STAFF RECOMMENDATION
702 Shelby Avenue
February 15, 2012

Application: Infill
District: Edgefield Historic Preservation Zoning Overlay
Council District: 06
Map and Parcel Number: 09304003800
Applicant: Peggy Newman, Designer
Project Lead: Sean Alexander, sean.alexander@nashville.gov

Description of Project: The applicant is proposing to construct a one and one-half story house. The house will be similar to historic Craftsman houses in character and scale, clad with contemporary materials (cement-fiber siding, split-faced concrete block foundation, fiberglass asphalt roof shingles). **Recommendation Summary:** Staff recommends approval of the proposed infill construction with the condition that staff review and approve the roof color, the final design of windows and doors, and fence material, and any new sidewalks or paving, otherwise finding the proposal to meet the design guidelines for the Edgefield Historic Preservation Zoning Overlay.	**Attachments** **A:** Photographs **B:** Site Plan **C:** Elevations

702 SHELBY AVE - SITE PLAN

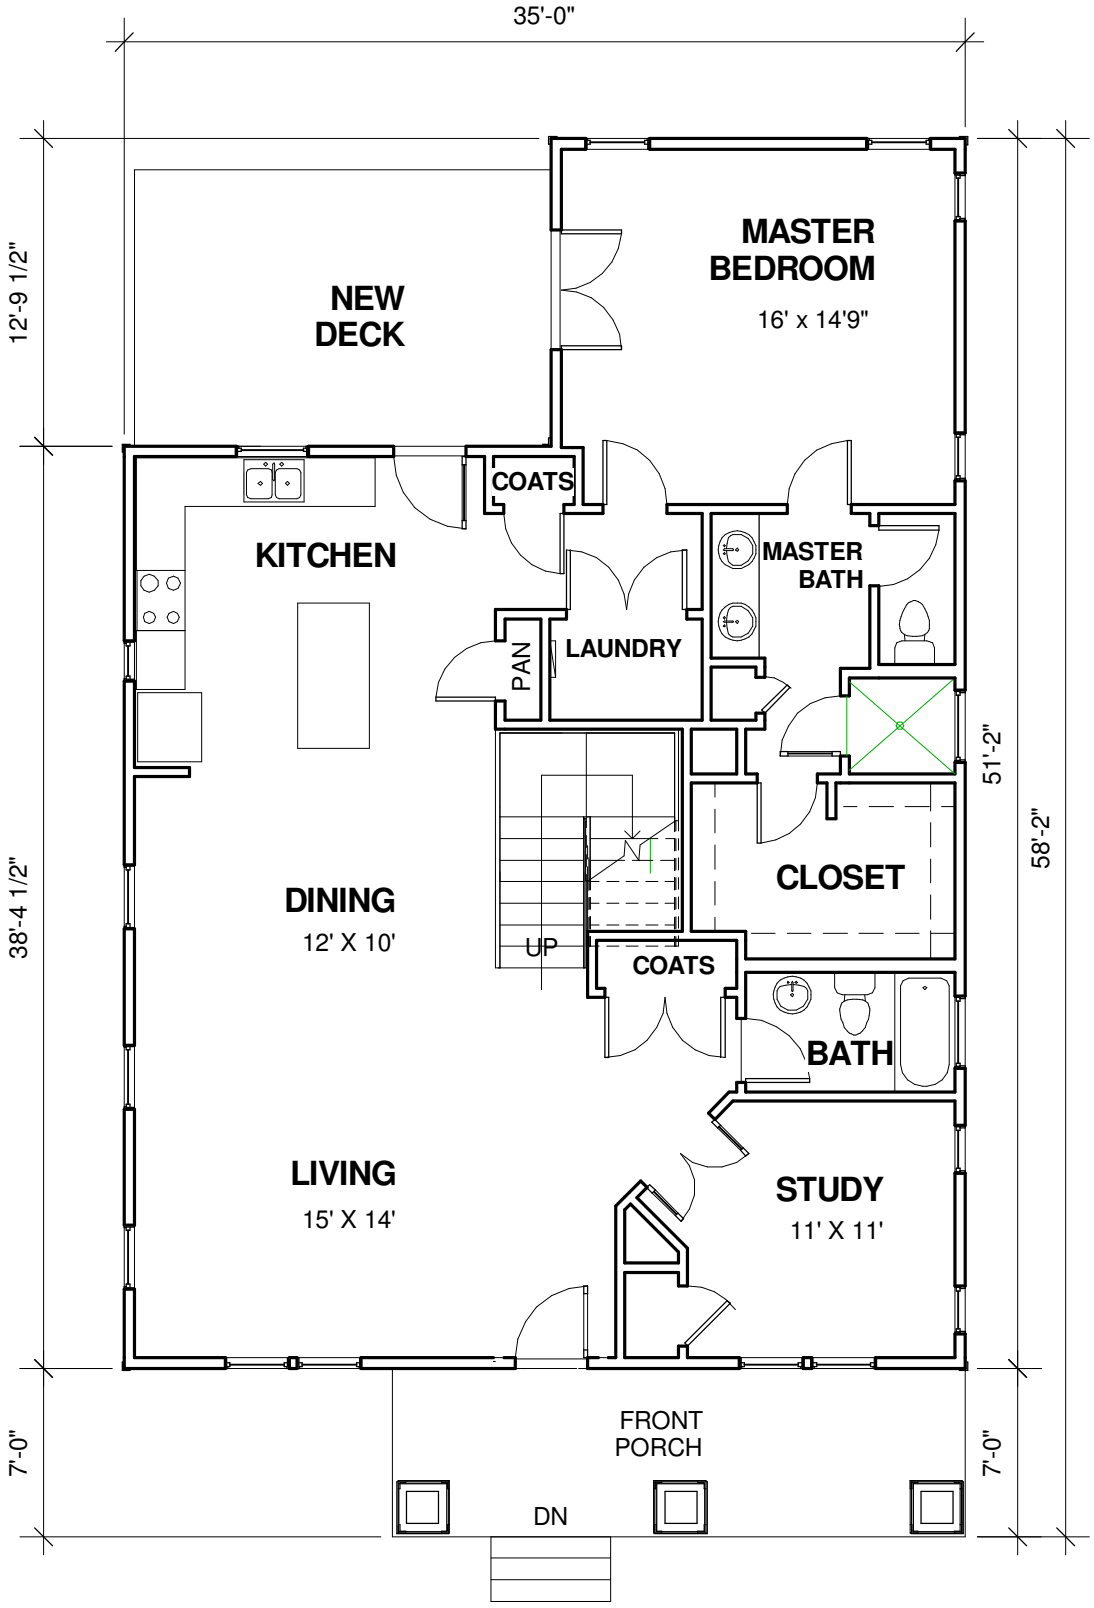
The structure will be a one and one-half story house designed in the tradition of the Craftsman architectural style that was popular in the in the 1920s and 30s. The form of the proposed house is a side-gabled bungalow oriented perpendicularly toward the street, matching the alignment and street setback of surrounding historic houses. The house will be shifted slightly right-of-center on the lot, but will maintain and reinforce the existing rhythm of houses on the street. The location of the house will meet guidelines III.B.2.a and III.B.2.e (Setbacks and Rhythm of Spacing, Orientation). The required five foot (5') side setback buffers will be met.

The locations of proposed fences and paving meet guidelines IV.B.1 and IV.B.2 (Fences, Permanent Landscape Features). Additional information about sidewalks and other paving needs to be provided and approved by staff before a permit is issued.

Staff recommends approval of the proposed infill construction with the condition that staff review and approve the roof color, the final design of windows and doors, and fence material, and any new sidewalks or paving, otherwise finding the proposal to meet the design guidelines for the Edgefield Historic Preservation Zoning Overlay.

702 SHELBY - FRONT ELEVATION

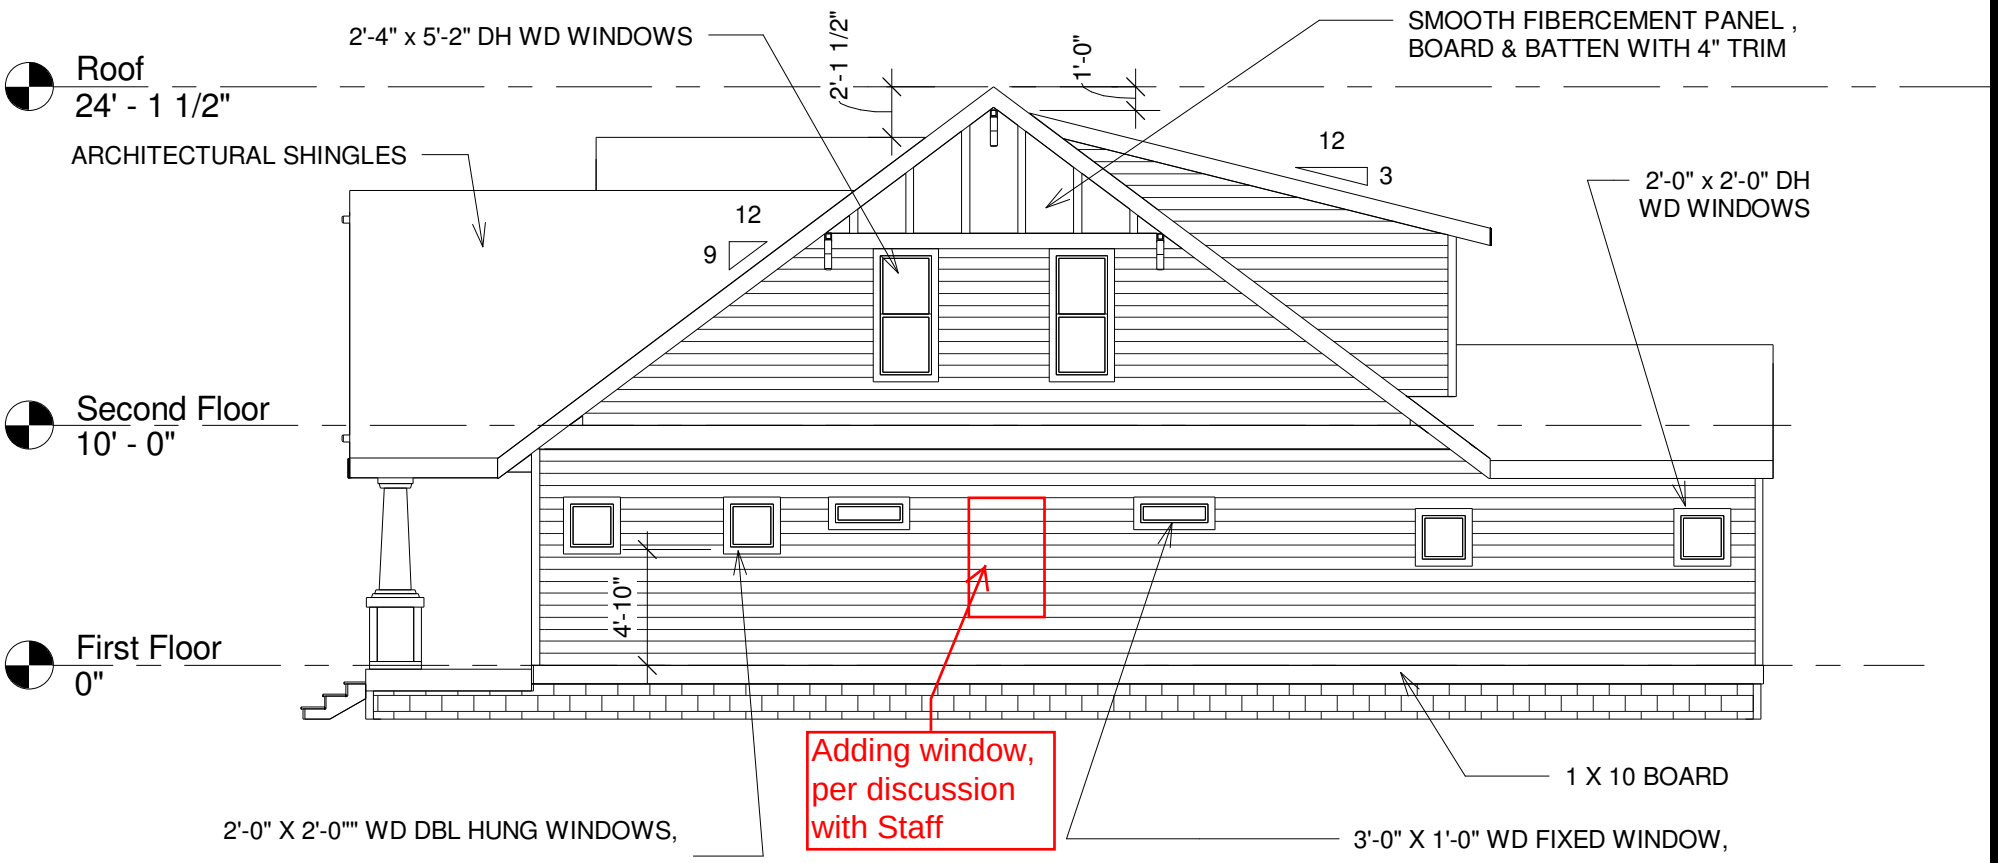
The finished floor height will match the foundation line of the structure at approximately two feet (2') above grade on a fairly flat lot. The primary eave height will be ten feet (10') above grade or eight feet (8') above the foundation line. The roof, a 9:12 pitched side-oriented gable, will rise to twenty-six feet (26') above grade. The front wall of the

house will be thirty-five feet wide, with a twenty-four foot (24') wide front porch with a front-gabled roof. These proportions are compatible with the house to the left, a typical historic Craftsman house that is thirty-four feet wide and twenty-seven feet tall. There will also be a gabled front dormer and a shed-roofed rear dormer, which are both similar to those on historic houses in scale and character. Overall, the proposal will meet guidelines II.B.2.b, III.B.2.c, III.B.2.d (Height, Building Shape, Roof Shape).

The front and sides of the house will have multiple openings, no more than ten feet (10') apart. There will be a square, wooden louvered vent in the gable field above the front porch. The proportion and rhythm of windows and doors on the front and sides of the structure will be compatible with surrounding historic buildings and meet guideline III.B.2.f.

The exterior materials of the new house will be: cement-fiber clapboard siding, smooth, with a five inch (5") reveal; cement-fiber "stucco" panels and trim to resemble half-timbering; split-faced concrete block foundation; and asphalt architectural roof shingles. The windows and doors will be wood. These materials are appropriate for new construction in the historic overlay and meet guideline III.B.2.g. Additional information about the roof color, the final design of windows and doors, and fence material, needs to be provided and approved by staff before a permit is issued,
